**Stage 1/2 Road Safety Audit
Housing Development Kinnegad, Co.
Westmeath**

Client:	JH KINNIE LTD.
Document No:	241139-ORS-XX-XX-RP-TR-13g-001 - RSA

This report documents the findings of a Stage 1/2 Road Safety Audit (RSA) carried out with respect proposed Housing Development in Kinnegad, Co. Westmeath.

Problem No.03: Proximity of Ramp Warning Signage

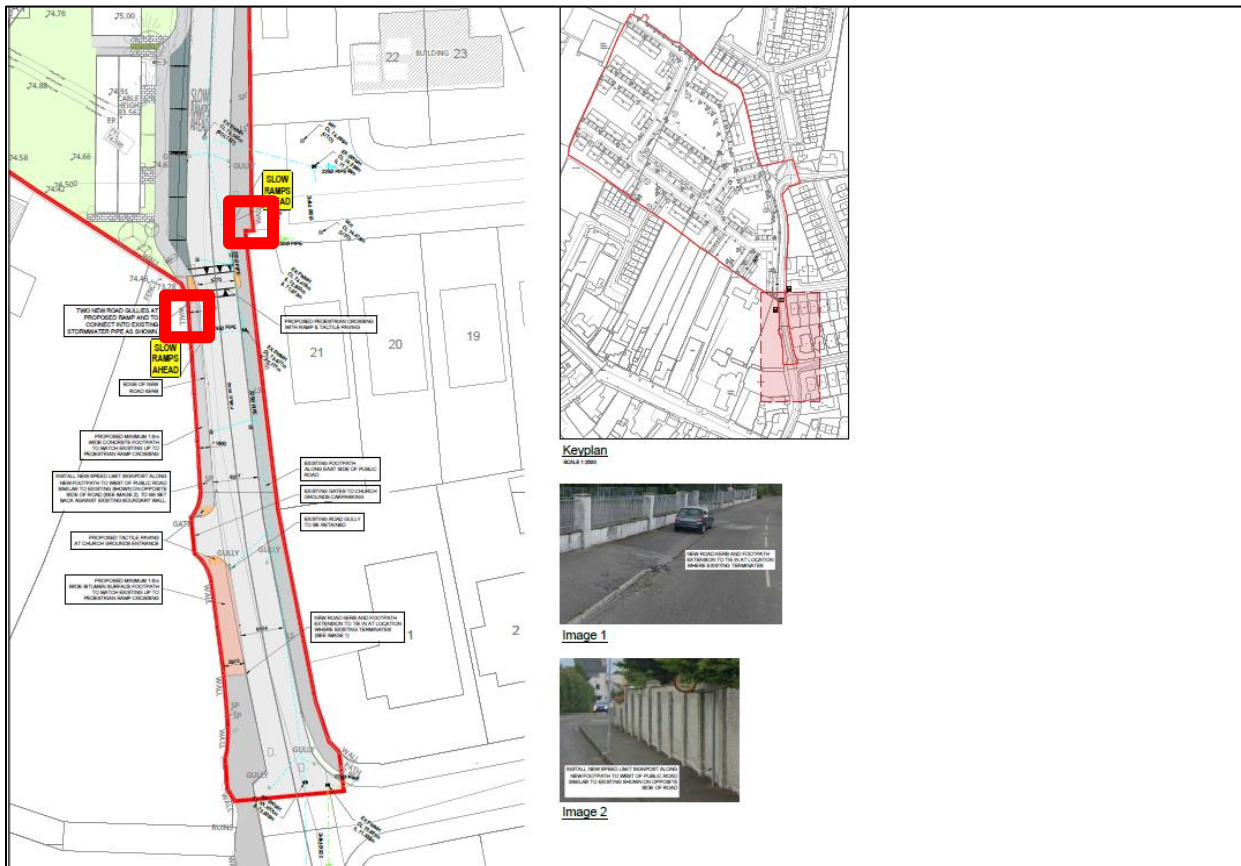
The audit team note that the proposed advanced warning for 'Ramp Ahead' is positioned close to the ramp. The audit team is concerned that this will not give motorists adequate advance warning of the impending hazard ahead and could result in an increased risk of collisions with pedestrians on the crossing causing injury.

The design team should provide the appropriate ramp sign with supplementary pedestrian warning signage the requisite distance from the hazard.

Problem No.04: Inappropriately Located Gullies

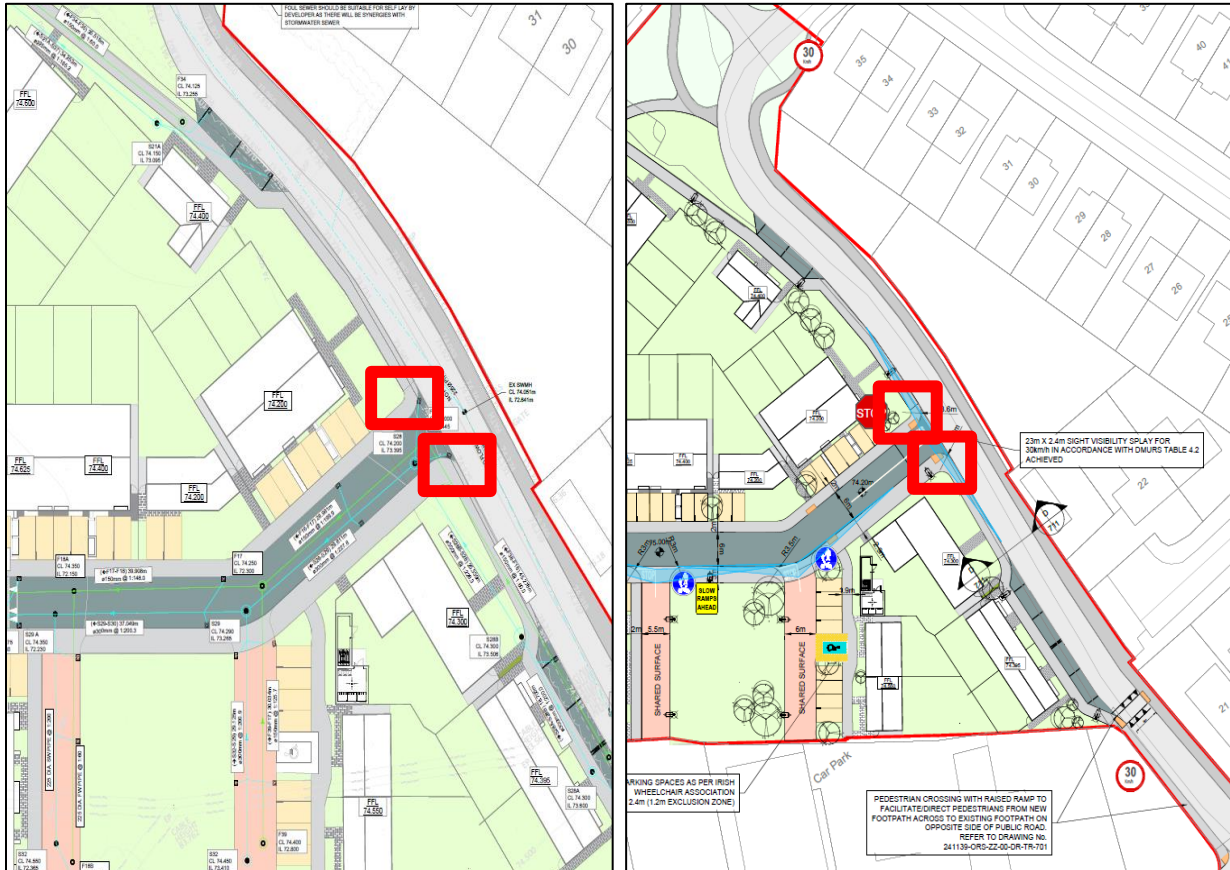
The audit team note from the drawings provided, that there are gullies located within areas designated for vulnerable road users at the locations identified. Inappropriate gully positioning may lead to potential trip and fall hazards for vulnerable users.

The design team should ensure drainage gullies are strategically positioned outside of pedestrian zones to mitigate the safety hazard identified.

Problem No.05: Utility Manhole Locations

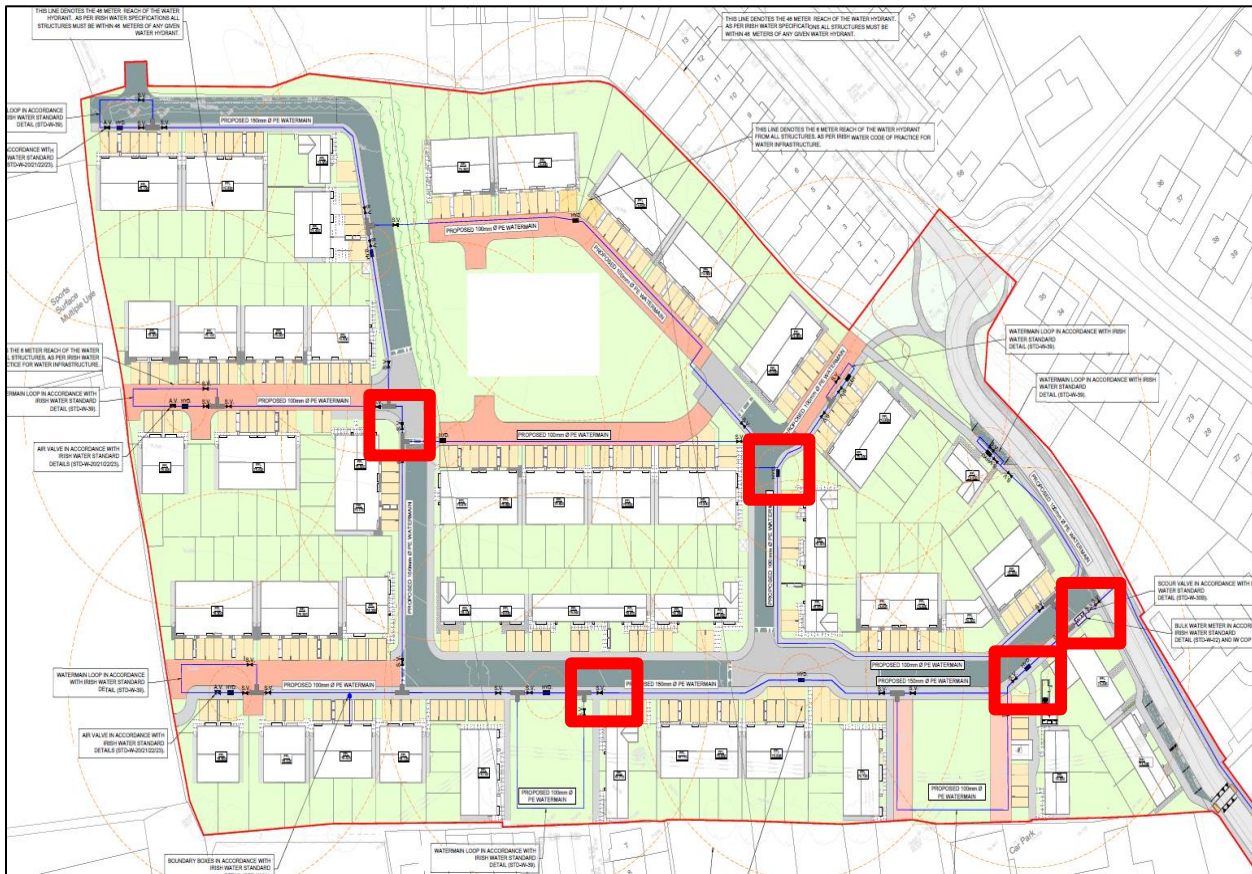
The audit team note from the provided drawings that utility manholes are proposed within areas designated for pedestrian crossings. It is not clear from the drawings provided if the utility manholes at the location identified are within the tactile paving. If crossings are not kept clear of manhole covers and are not level with the pavement surface or should the surface be slippery, it may pose challenges for vulnerable road users, potentially resulting in trips and falls.

The design team should ensure that manholes are positioned outside of the crossing zone and finished level with the surface.

Problem No.07: Dropped Kerbs Provisions for Mobility Impaired Users

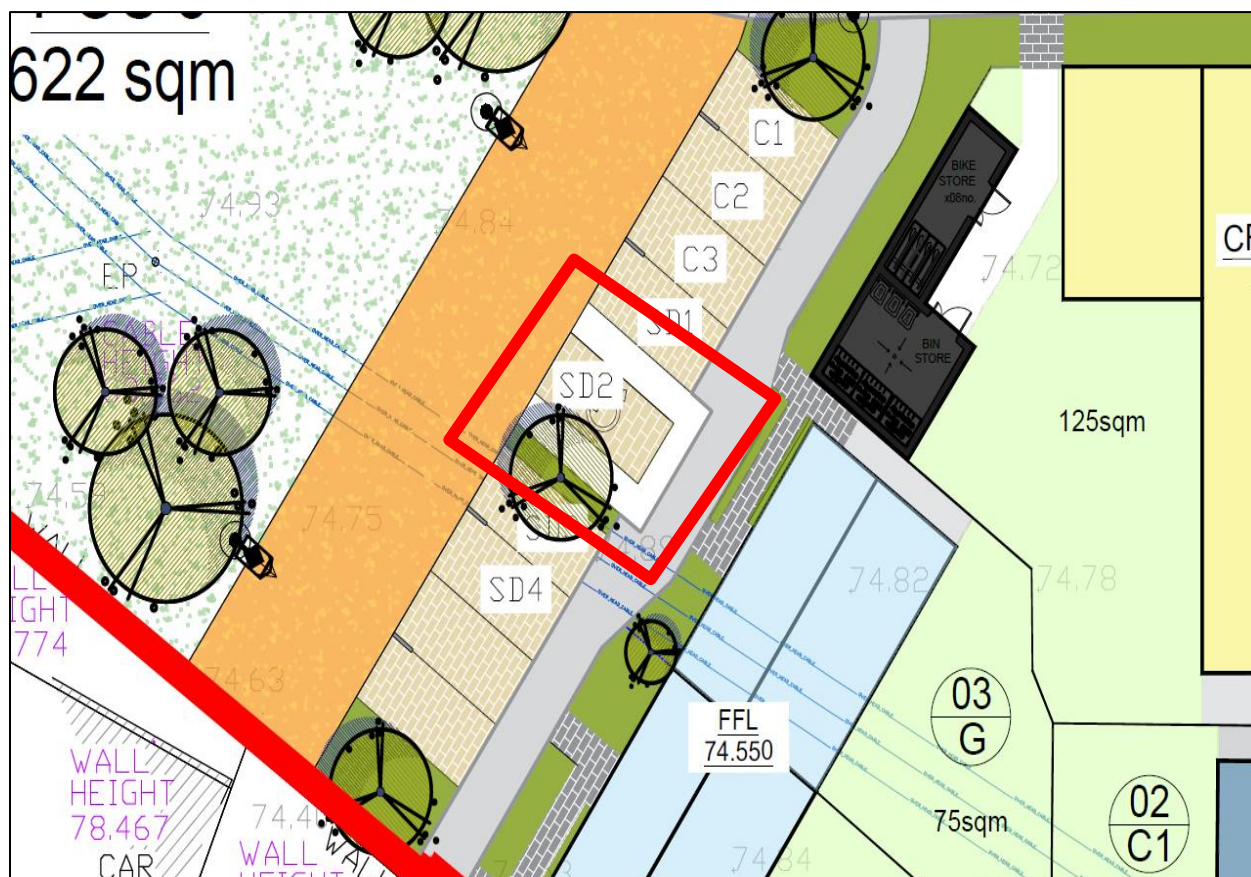
The audit team note from the drawings provided, that there is disabled parking spaces provided within development. It is not clear from the drawings provided if appropriate dropped kerbing is provided for these spaces at the locations identified below. The audit team are concerned that users of the spaces may not have access to the footpath and may use the closest road to access the footpath resulting in potential collisions between vehicles and vulnerable road users.

The design team should provide adequate provision for users of the spaces to access the footpath safely.

Problem No.08: Vehicular Entrances

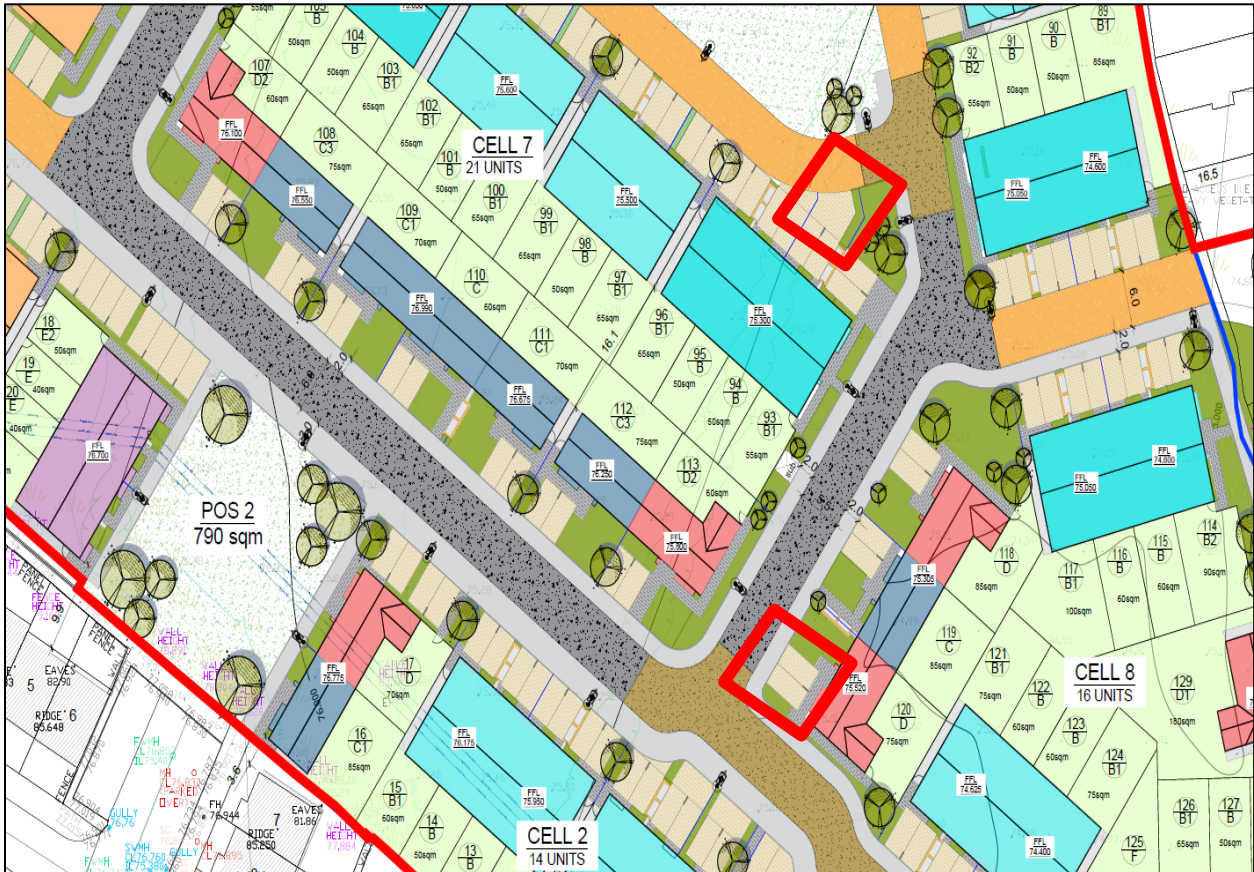
The audit team note from the drawing's provided that the vehicular entrance to the properties identified are on the inside radius of the turn and may not be adequately sighted when travelling along the main access road. The audit team would have concern's that vehicles exiting the site would not have full visibility of oncoming traffic and likewise oncoming traffic may not have sufficient forward visibility resulting in vehicular collisions.

The design team should ensure that the boundary treatments do not impeded visibility from the parking spaces or forward visibility
